**CONSTRUCTION PROGRESS MEETING MINUTES - #10**

Re: Renovation to Radcliff Elementary School – Phase 3  
SCB Project No. 1004

## Field Report

PROJECT: Radcliff Phase III	PROJECT NO.: 1055
DATE: 11-23-11	COMPANY: SCB
FROM: Whitley Casey	ATTN: Myra Vaughn

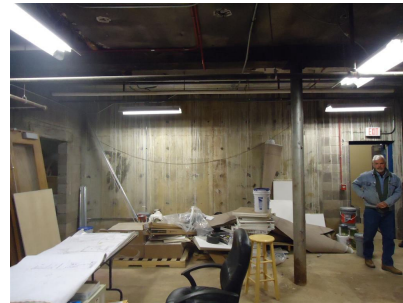
Water infiltration through sealed existing coal chute. The area of saturation of the coal chute is approximately 3-5 feet below exterior grade. The coal chute is located in Storage Room 002.

The existing concrete walls adjacent to the coal chute also show signs of water infiltration. These surfaces were “wet” to the touch.

Across the room from exterior wall of the coal chute, standing water was noted at the southeast corner of Storage Room 002. Upon closer investigation, it appeared that water infiltration was occurring from under the existing concrete slab – hydrostatic pressure.

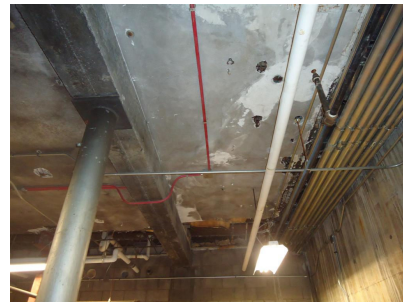
The hole into the existing chimney at left of exterior double-doors is to be infilled per construction documents.

Per construction drawings, “the contractor shall fire safe and seal all existing and new penetrations in existing walls and/or new walls (and/or floor above where applicable) as required to achieve rated construction as indicated. All abandoned existing openings shall be infilled as required to achieve rating as indicated.”

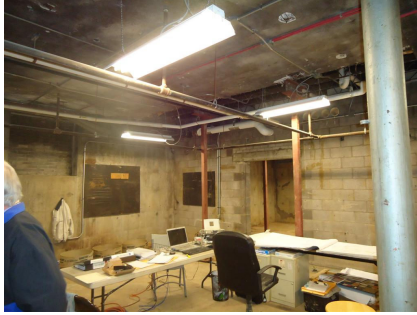
Per demolition drawings “Remove existing plaster ceiling assembly at underside of steel floor or roof joists above, including plaster, mesh, and any furring.”

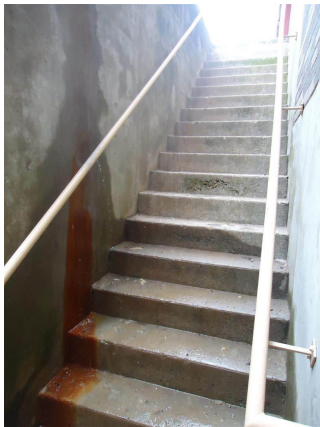
Per construction drawings and room finish groups, the lower level areas Storage Room 001, 002, and 003, are to have existing exposed concrete floor, no new wall base, new paint at existing/new walls, and paint to exposed structure above. All new and existing exposed lintels to receive paint. Existing steel columns to receive paint.

*Owner to verify if these spaces are not to receive new finishes indicated per construction documents.*

Several new light fixtures and other MEP items are currently supported by existing plaster ceiling above. Refer to MEP construction drawings for requirements.
